CURRENT PLANNING CASE INFORMATION

Plan/Case Information:

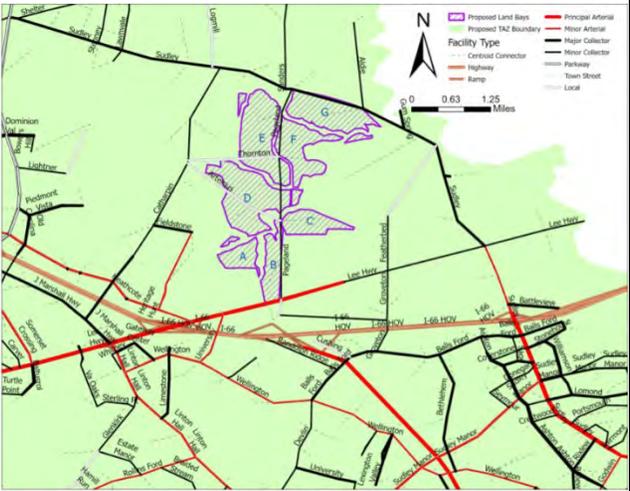
VIRGINIA DEPARTMENT OF TRANSPORTATION PRINCE WILLIAM LAND USE PROJECT REVIEW COMMENT AND RESOLUTION SHEET				TIA NOT REQUIRED		COMMENT CATEGORIES: 1. REQUIREMENT 2. RECOMMENDATION 3. CLARIFICATION	
COUNTY PROJECT NUMBER: CPA 2021-00004			DEVELOPER/ENGINEER: MARY ANN GHADBAN / CHRISTOPHER CONSULTANTS		REVIEWER(S): ERIK SPENCER, P.E. ERIK.SPENCER@VDOT.VIRGINIA.GOV		DATE: 03/11/22
PROJECT NAME: PW DIGITAL GATEWAY			REVIEW PHASE & TYPE: 1ST REVIEW, CPA		DISCIPLINE: VDOT

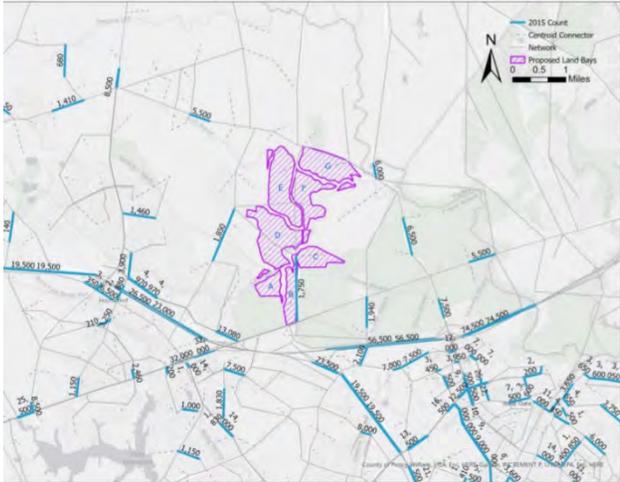
VIRGINIA DEPARTMENT OF TRANSPORTATION PRINCE WILLIAM LAND USE PROJECT REVIEW COMMENT AND RESOLUTION SHEET			TIA NOT REQUIRED		COMMENT CATEGORIES: 1. REQUIREMENT 2. RECOMMENDATION 3. CLARIFICATION	
COUNTY PROJECT NUMBER: CPA 2021-00004		DEVELOPER/ENGINEER: MARY ANN GHADBAN / CHRISTOPHER CONSULTANTS		REVIEWER(S): ERIK SPENCER, P.E. ERIK.SPENCER@VDOT.VIRGINIA.GOV		DATE: 03/11/22
PROJECT NAME: PW DIGITAL GATEWAY		REVIEW PHASE & TYPE: 1 ST REVIEW, CPA		DISCIPLINE: VDOT
